TRAFFIC SIGNAL INVENTORY DIAGRAM

AMADOR, CARGO, ILLINOIS INTERSECTION

CNN NO:
54159000

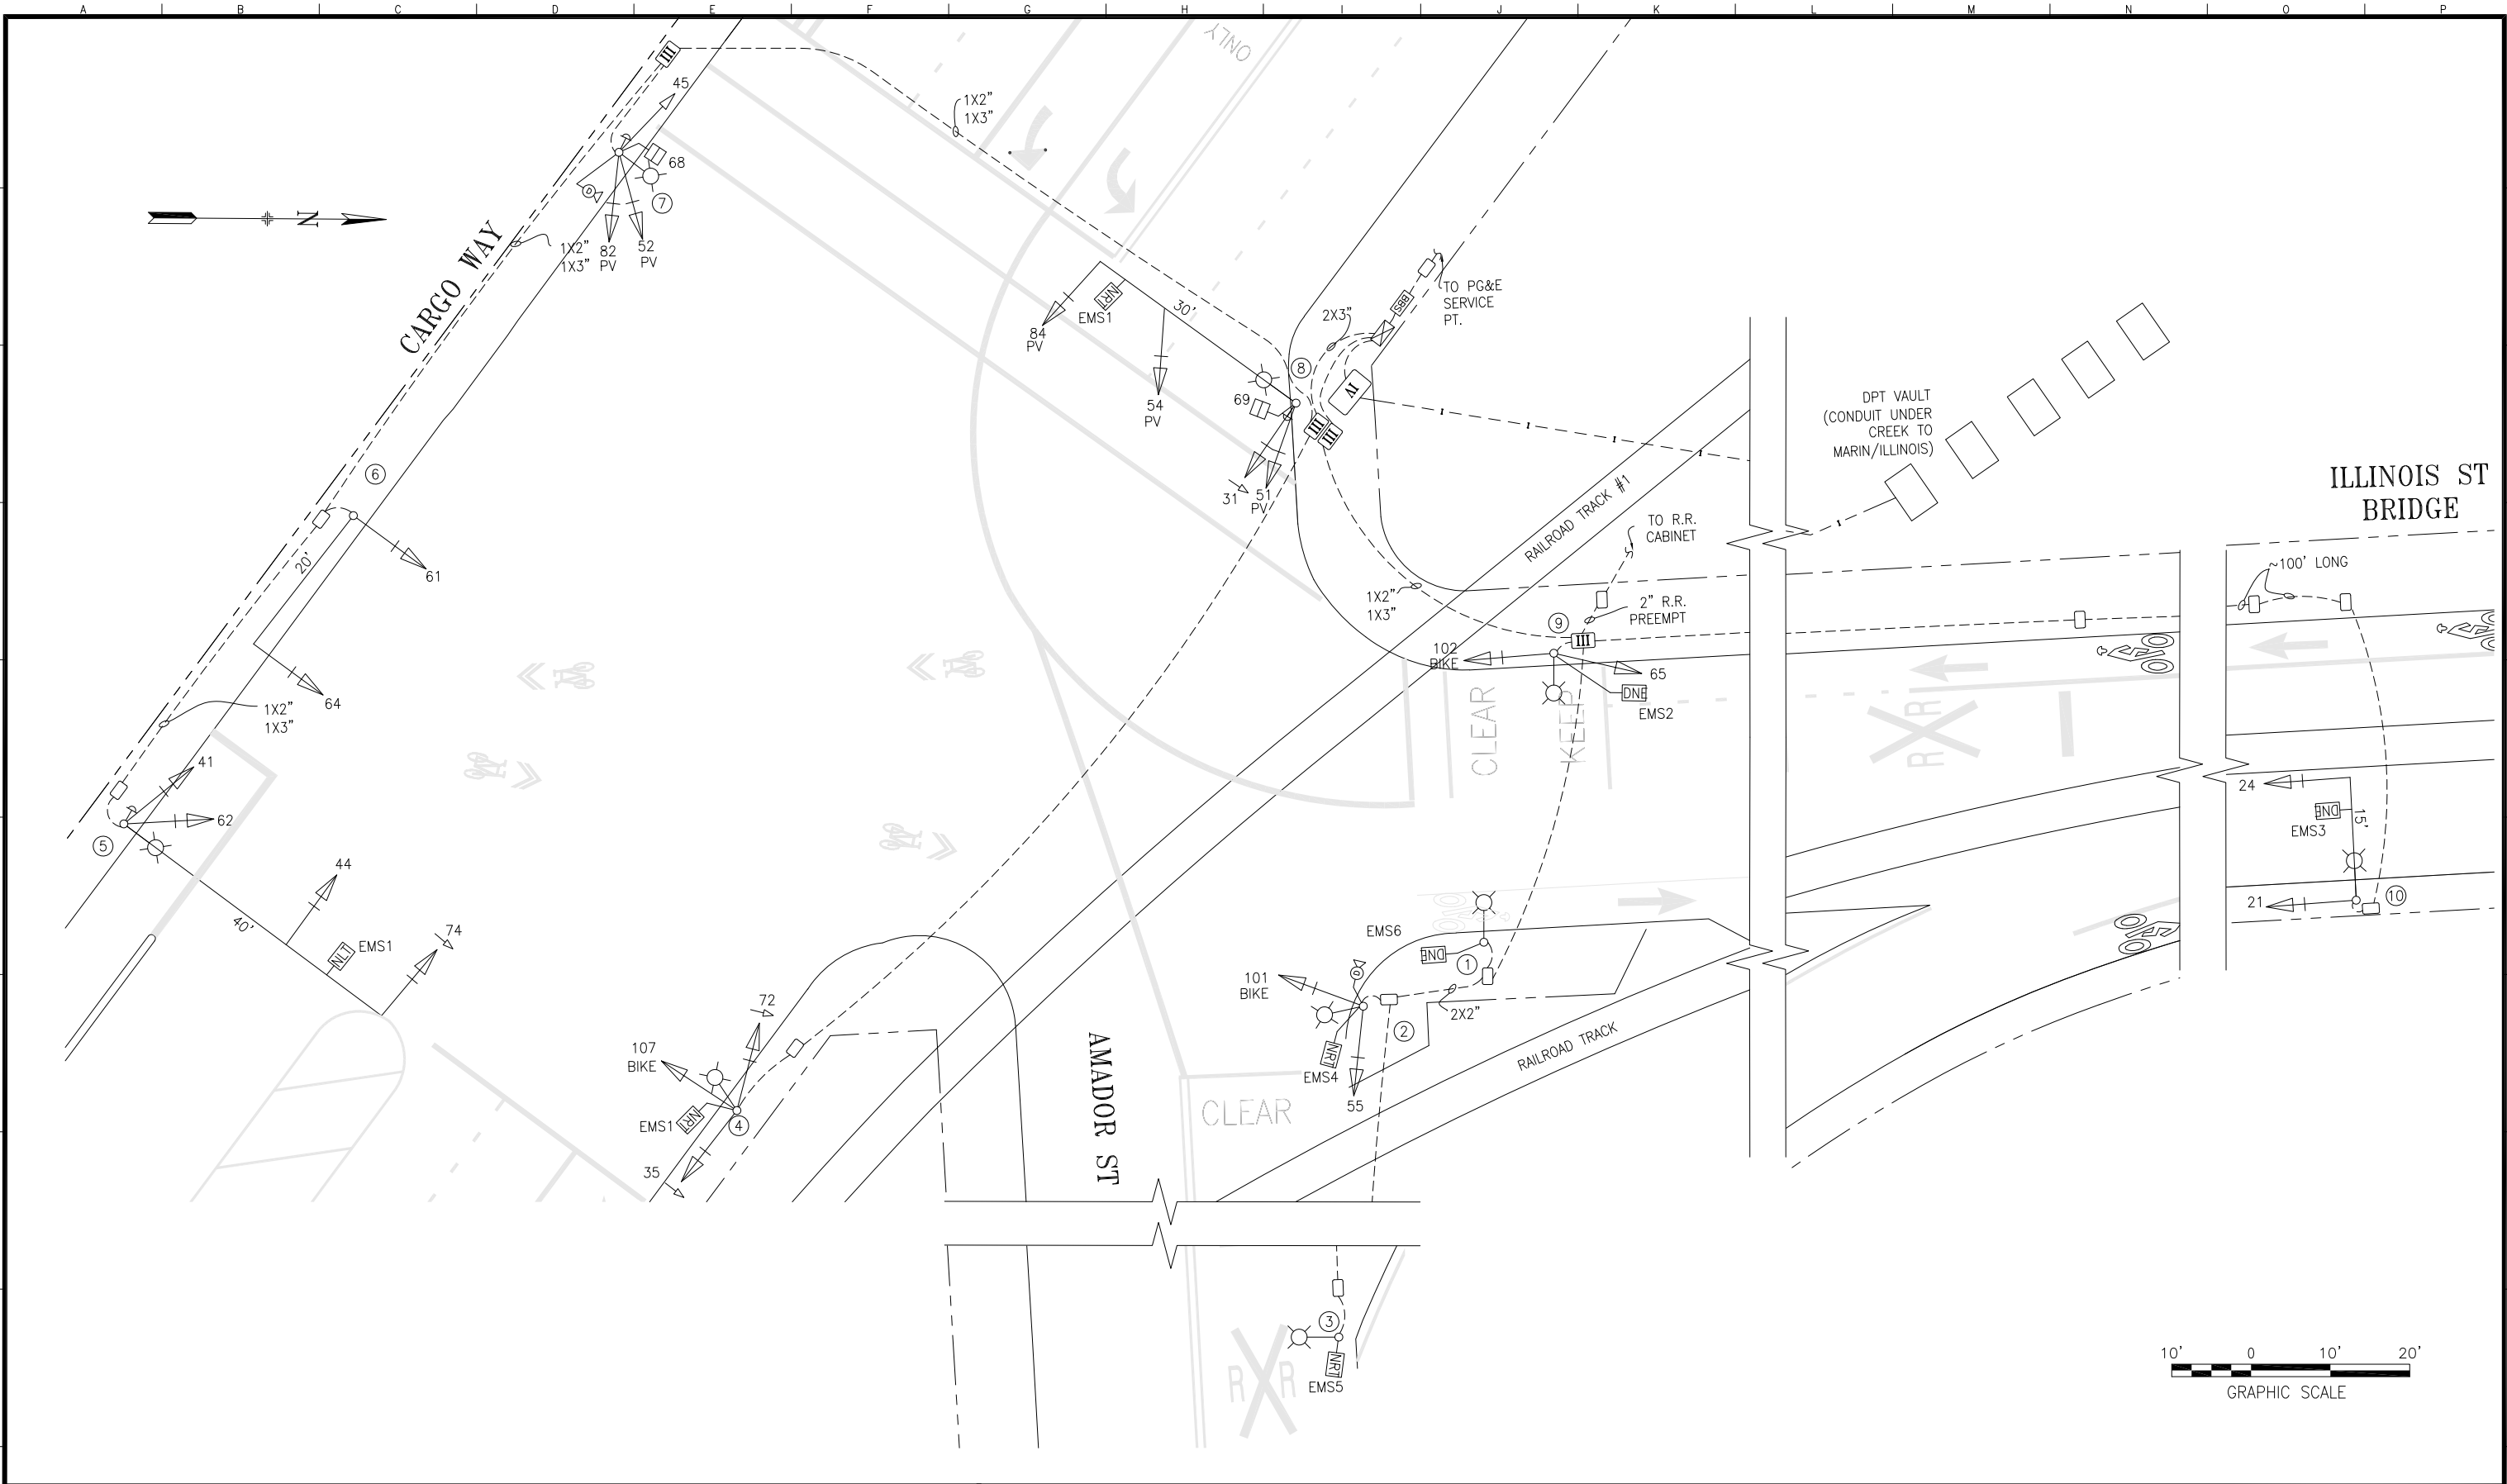
4	10/14/22	SRC 2022-248. CHANGE SIGNAL 35 FROM 3S12" TO 3S12"RA	D Yeung	G de Leon
3	9/22/22	REPLACE EX VIDEO DETECTION WITH NEW VIDEO DETECTION UNITS ON POLES 2 & 7	D Yeung	G de Leon
2	9/20/22	UPDATE PER FIELD. 65 IS 3S12" & NO BP. RELABEL 81/85 AS 31/35. 31 IS NOT PV. 35 IS 3S12" LABEL EMS PER TIMING CARD	D Yeung	G de Leon
1	8/2/12	ADDED BICYCLE SIGNALS AND DETECTION FOR NORTHBOUND CARGO WAY CYCLETRACK	J Shahamiri	D Curtis
0	7/16/08	ILLINOIS ST BRIDGE PROJECT	D Yeung	A Herce
NO.	DATE	DESCRIPTION	BY	APPROVED
TABLE OF REVISIONS				
CHECKOUT DRAWING THROUGH THE SID CUSTODIAN FOR THE LATEST REVISION
